# Access Compliance Report

### (Curb Ramps)

Intersection ID: 27708	Main Street: BREM_LN	Cross Street: LEDERER_AV	Location: NE
ADA ID: 7F854D41528F	Ramp Type: Perp	Initial Pass/Fail: Fail	Overall Compliance: No
			Severity Score: 21.25

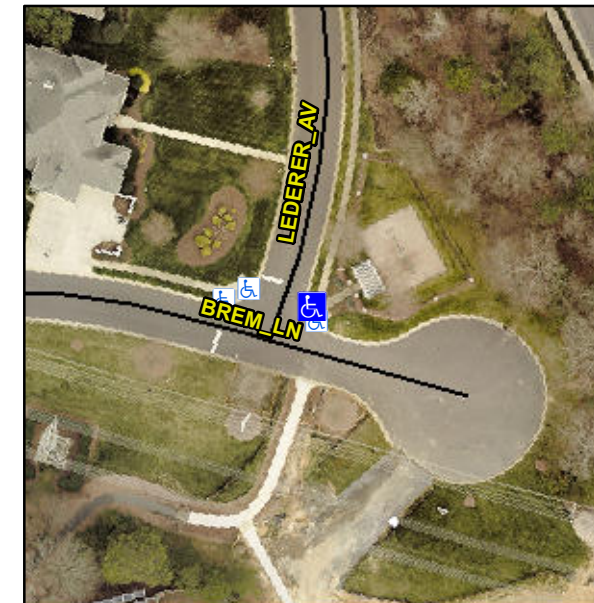
**Not Found, R304.5.1, R304.5.3**

Compliance	Description	Data	Compliance	Description	Data
N/A	Ramp Length (in)	51.0	Yes	Ramp Slope (%)	6.7
No	Ramp Width (in)	47.0	No	Ramp XSlope (%)	5.8
N/A	Flare Type LT	N/A	N/A	Flare Type RT	N/A
N/A	Flare Slope LT (%)	N/A	N/A	Flare Slope RT (%)	N/A
N/A	Flare Traversable LT?	N/A	N/A	Flare Traversable RT?	N/A
N/A	Landing Length (in)	N/A	N/A	DWS Provided?	N/A
N/A	Landing Width (in)	N/A	N/A	DWS Contrast?	N/A
N/A	Landing Slope (%)	N/A	N/A	DWS Length (in)	N/A
N/A	Landing X Slope (%)	N/A	N/A	DWS Full Width?	N/A
N/A	Landing Curb? (Y/N)	N/A	N/A	DWS Offset (in)	N/A
N/A	Shared Landing?	N/A			
N/A	Gutter Ponding?	N/A	N/A	Gutter Slope (%)	N/A
N/A	Gutter Lip Ht (in)	N/A	N/A	Gutter X Slope (%)	N/A
N/A	Painted X Walk1?	No	N/A	Painted X Walk2?	N/A
	X Walk 1 Direction	To NW		X Walk 2 Direction	N/A
N/A	X Walk 1 Width (in)	N/A	N/A	X Walk 2 Width (in)	N/A
	X Walk 1 Slope (%)	5.1		X Walk 2 Slope (%)	N/A
	X Walk 1 X Slope (%)	4.3		X Walk 2 X Slope (%)	N/A

**Remove & Replace Entire Ramp.**
